Project: IEEE P802.15 Working Group for Wireless Personal Area Networks (WPANs)

Submission Title: [Consideration of MR-FSK Channelization and Clock Frequency Tolerance Using Filtered FSK]

Date Submitted: [18 January, 2011]

Consideration of MR-FSK Channelization and Clock Frequency Tolerance Using Filtered FSK

Filtered FSK Signals at 915 MHz, ± 30 ppm (1)

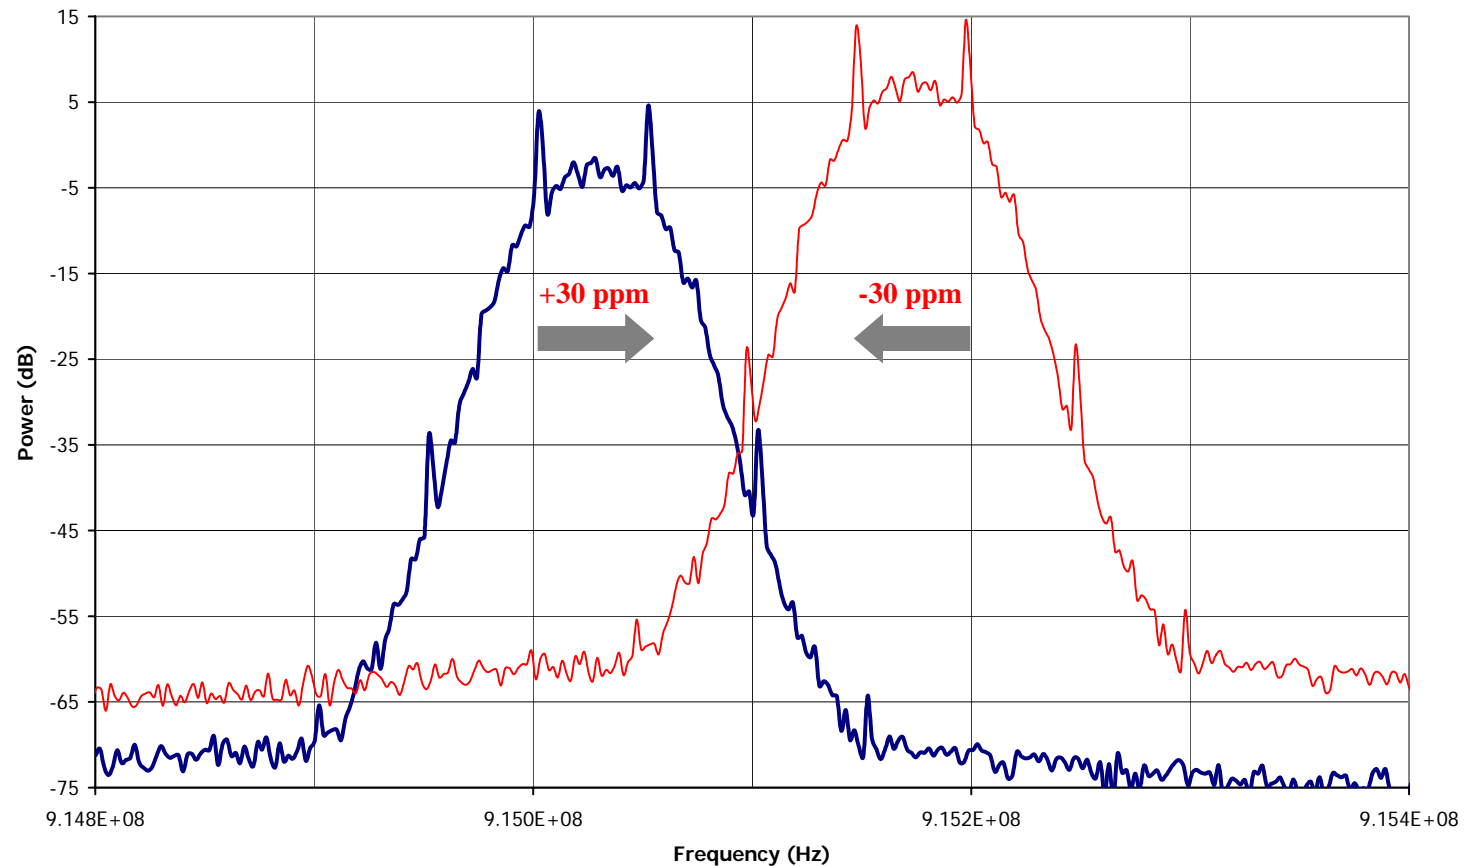
- Negligible interfering power leakage from adjacent channel at max frequency tolerance and worst case offset.

Filtered FSK Signals at 915 MHz, ± 30 ppm (2)

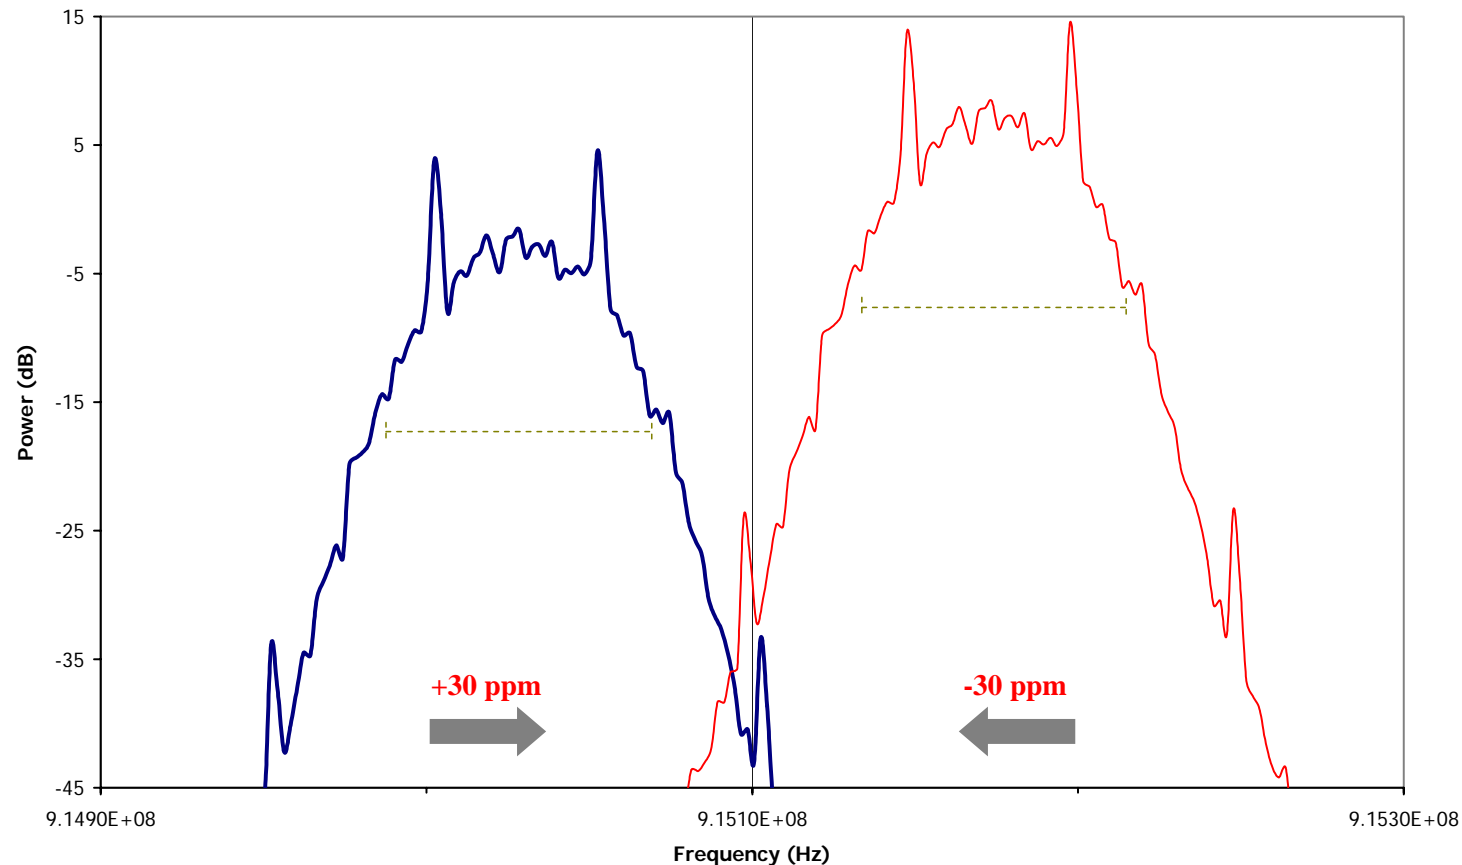
- Excellent conditions for signal demodulation at max frequency tolerance and worst case offset.

Filtered FSK Signals at 2450 MHz, ± 15 ppm (1)

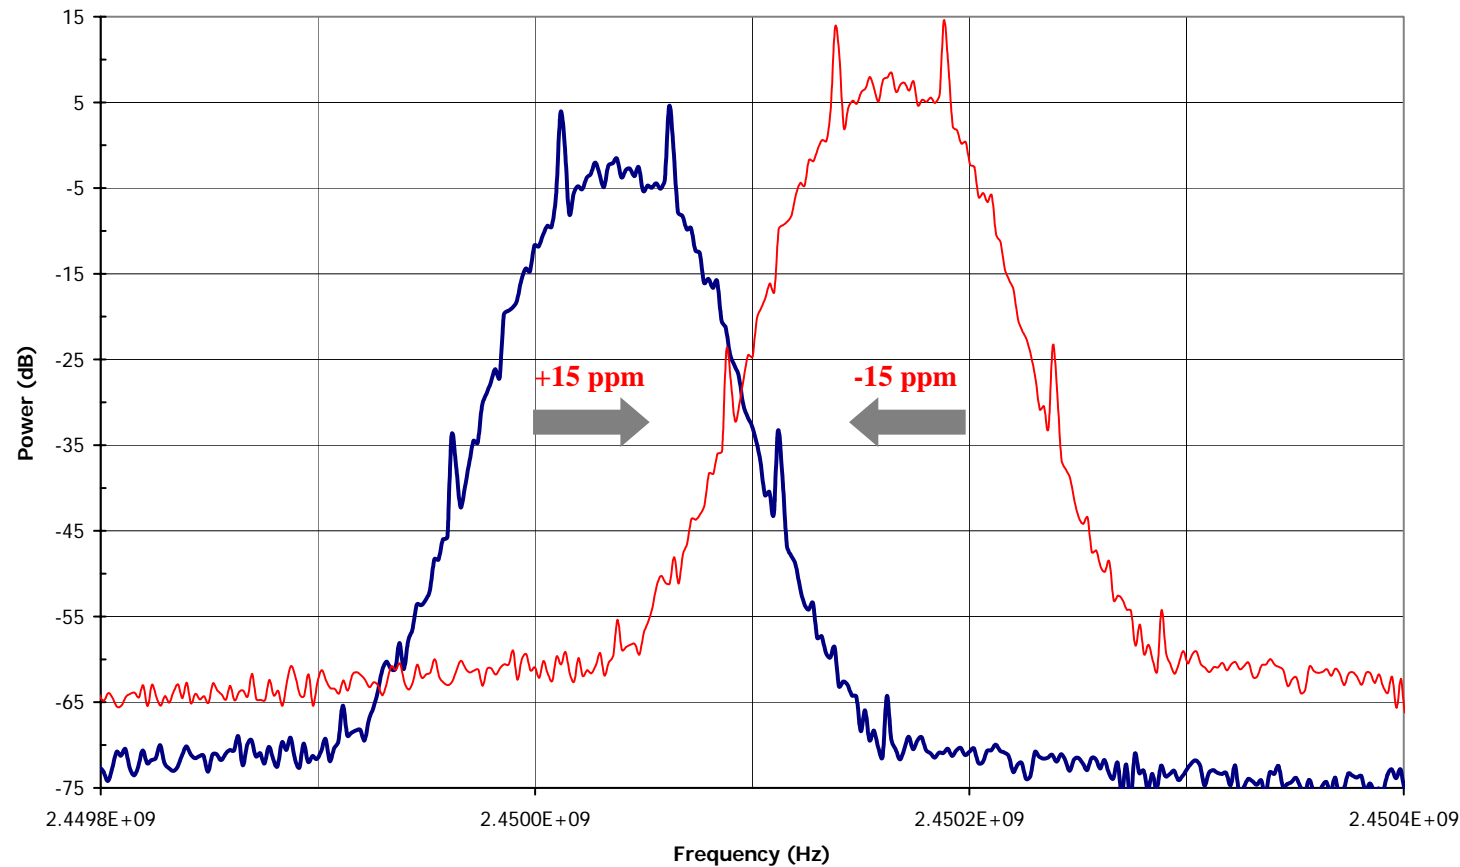
- Negligible interfering power leakage from adjacent channel at max frequency tolerance and worst case offset.

Filtered FSK Signals at 2450 MHz, ± 15 ppm (2)

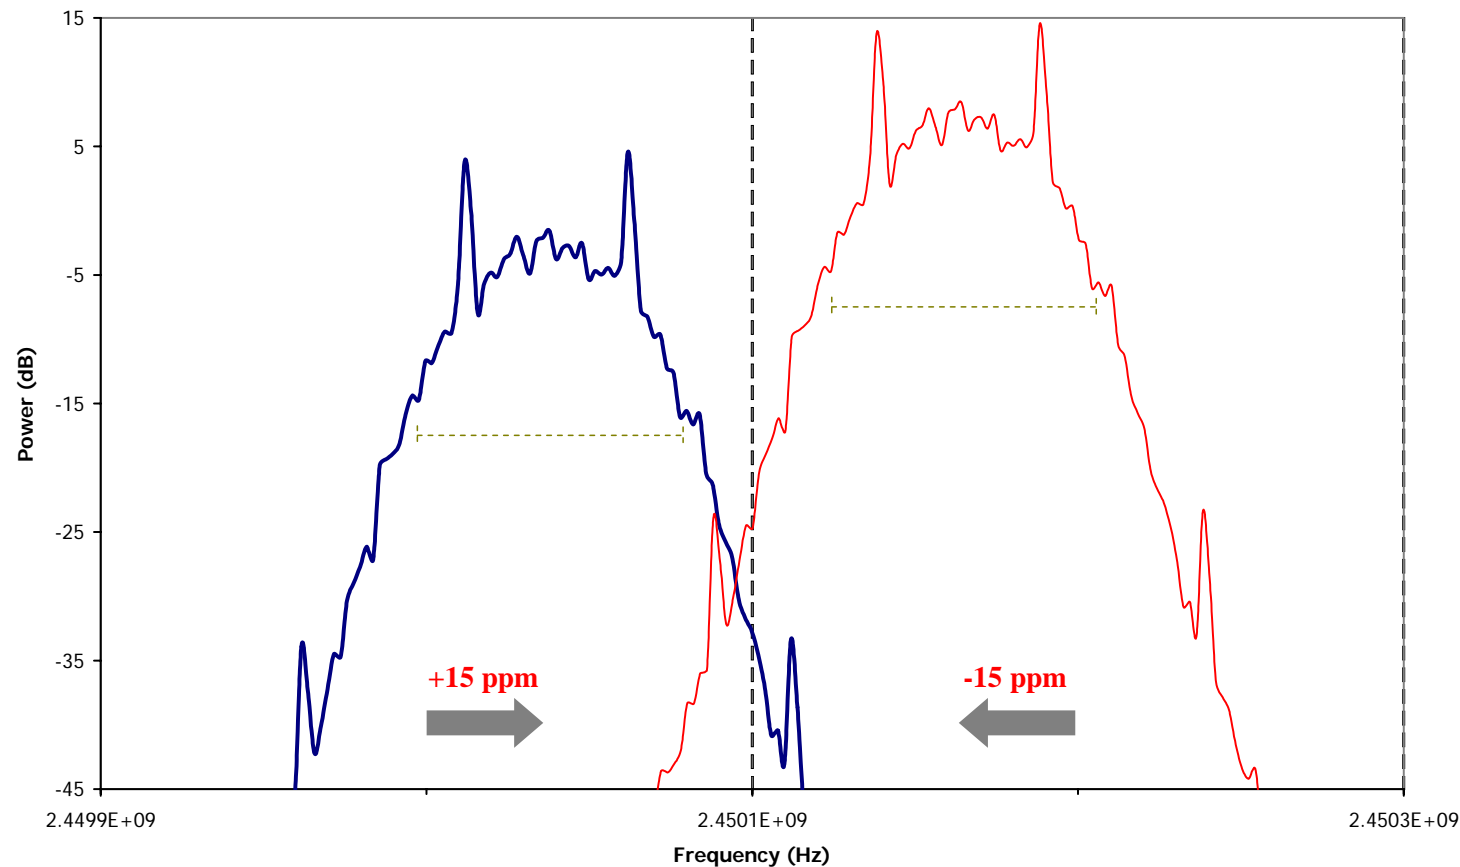
- ± 15 ppm (max frequency tolerance)
- Worst case frequency offset
- All signal power contained within the channel
- Good conditions for signal demodulation

Filtered FSK Signals at 2450 MHz, ± 20 ppm

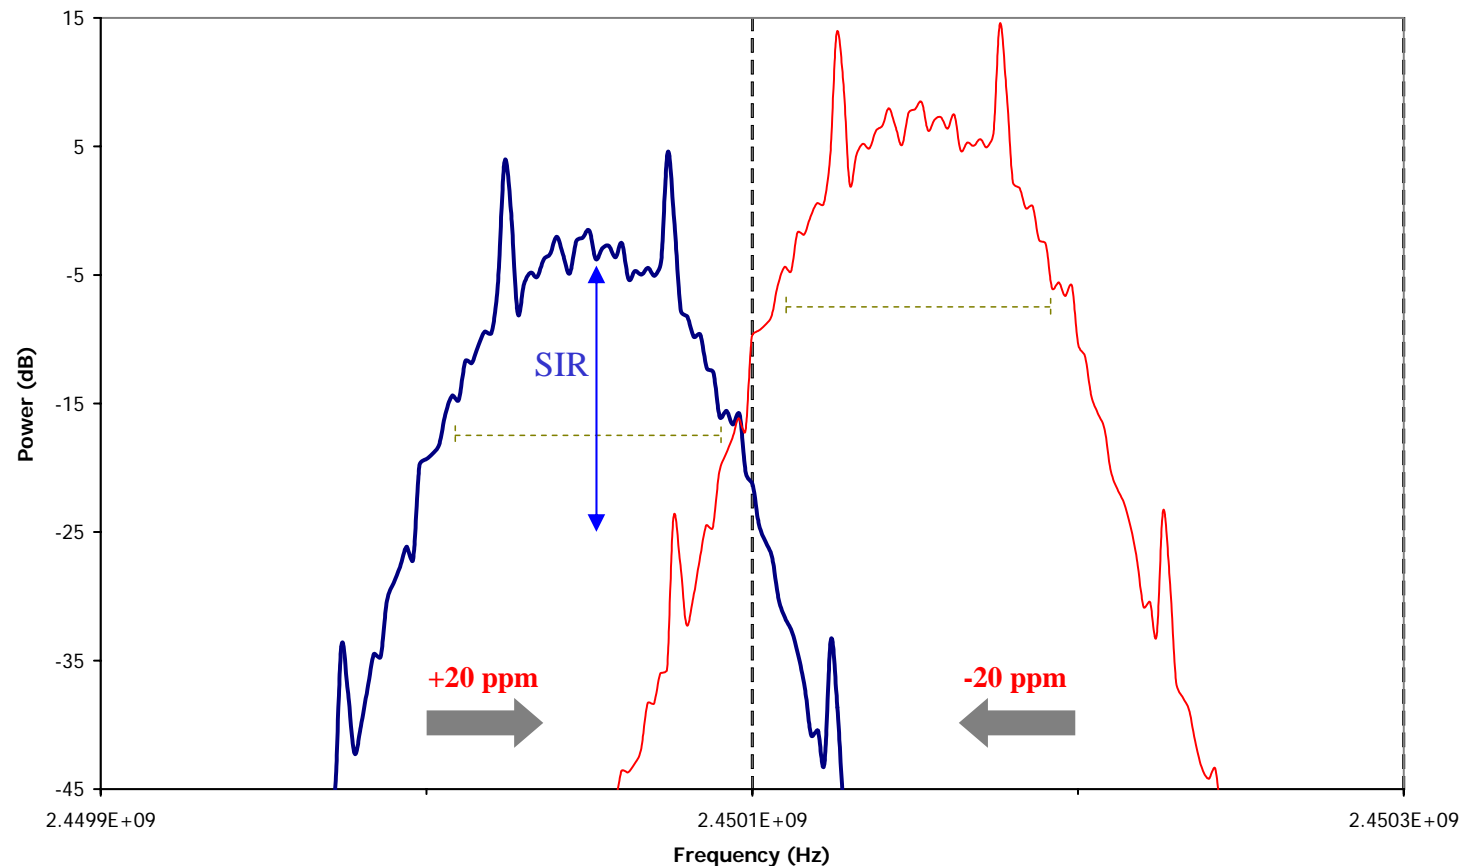
- ± 20 ppm (33% higher than currently specified)
- Worst case frequency offset
- Most of signal power (>99%) still contained within the channel
- Adequate conditions for signal demodulation
